PIC18(L)F1XK22 Family Silicon Errata and Data Sheet Clarification

The PIC18(L)F1XK22 family devices that you have received conform functionally to the current Device Data Sheet (DS40001365F), except for the anomalies described in this document.

FIGURE 1: INSTRUCTION CYCLE DELAY CALCULATION EXAMPLE

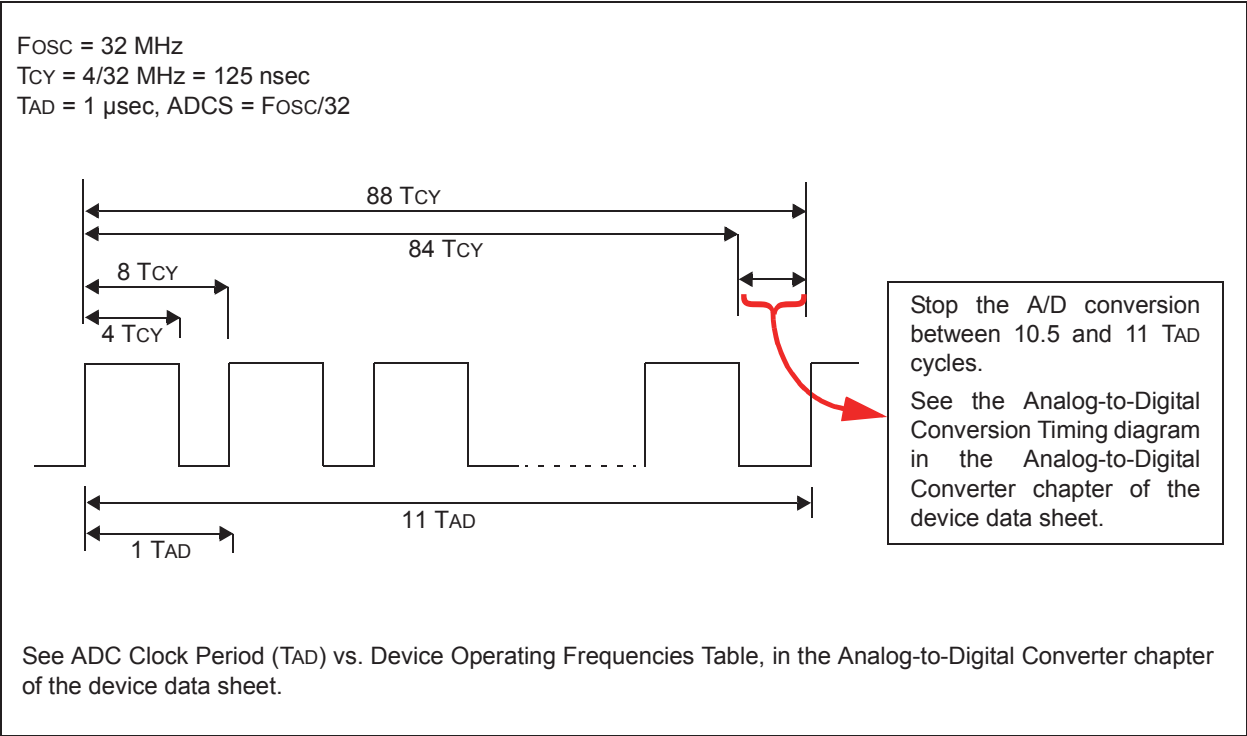
1.2 ADC Conversion Does Not Complete

An ADC conversion may not complete under these conditions:

1. When Fosc is greater than 8 MHz and is the clock source used for the ADC converter.
2. The ADC is operating from its dedicated internal FRC oscillator and the device is not in Sleep mode (an Fosc frequency).

When this occurs, the ADC Interrupt Flag (ADIF) does not get set, the GO/DONE bit does not get cleared, and the conversion result does not get loaded into the ADRESH and ADRESL result registers.

Method 3: Method 3 is provided if the application cannot use Sleep mode and requires continuous operation at frequencies above 8 MHz. This method requires early termination of an ADC conversion. Provide a fixed time delay in software to stop the Analog-to-Digital conversion manually, after all ten bits are converted, but before the conversion would complete automatically. The conversion is stopped by clearing the GO/DONE bit in software. The GO/DONE bit must be cleared during the last ½ TAD cycle, before the conversion would have completed automatically. Refer to [Figure 1](#) for details.

In Figure 1, 88 instruction cycles (TCY) will be required to complete the full conversion. Each TAD cycle consists of eight TCY periods. A fixed delay is provided to stop the A/D conversion after 86 instruction cycles and terminate the conversion at the correct time as shown in the figure above.

Note: The exact delay time will depend on the TAD divisor (ADCS) selection. The TCY counts shown in the timing diagram above apply to this example only. Refer to Table 3 for the required delay counts for other configurations.
